Access Compliance Report

Public Rights-of-Way

(Curb Ramps)

Intersection ID: 10032967	Main Street: NEWBURY GROVE ST	Cross Street: N/A	Location: NE
ADA ID: D8DEFD6F0116	Ramp Type: Perp	Initial Pass/Fail: Fail	Overall Compliance: No
Severity Score: 8.75			
Codes/Mitigation Info/Possible Solution		Field Measurements/Component Compliance

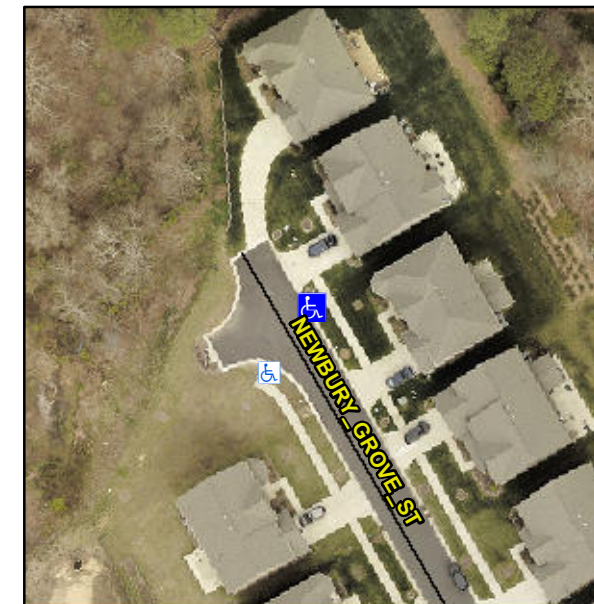
Not Found, R304.5.1

Compliance	Description	Data	Compliance	Description	Data
N/A	Ramp Length (in)	94.0	Yes	Ramp Slope (%)	5.3
No	Ramp Width (in)	47.0	Yes	Ramp XSlope (%)	0.2
N/A	Flare Type LT	N/A	N/A	Flare Type RT	N/A
N/A	Flare Slope LT (%)	N/A	N/A	Flare Slope RT (%)	N/A
N/A	Flare Traversable LT?	N/A	N/A	Flare Traversable RT?	N/A
N/A	Landing Length (in)	N/A	N/A	DWS Provided?	N/A
N/A	Landing Width (in)	N/A	N/A	DWS Contrast?	N/A
N/A	Landing Slope (%)	N/A	N/A	DWS Length (in)	N/A
N/A	Landing X Slope (%)	N/A	N/A	DWS Full Width?	N/A
N/A	Landing Curb? (Y/N)	N/A	N/A	DWS Offset (in)	N/A
N/A	Shared Landing?	N/A			
N/A	Gutter Ponding?	N/A	N/A	Gutter Slope (%)	N/A
N/A	Gutter Lip Ht (in)	N/A	N/A	Gutter X Slope (%)	N/A
N/A	Painted X Walk1?	No	N/A	Painted X Walk2?	N/A
	X Walk 1 Direction	To SW		X Walk 2 Direction	N/A
N/A	X Walk 1 Width (in)	N/A	N/A	X Walk 2 Width (in)	N/A
	X Walk 1 Slope (%)	1.5		X Walk 2 Slope (%)	N/A
	X Walk 1 X Slope (%)	2.7		X Walk 2 X Slope (%)	N/A

Remove & Replace Entire Ramp.
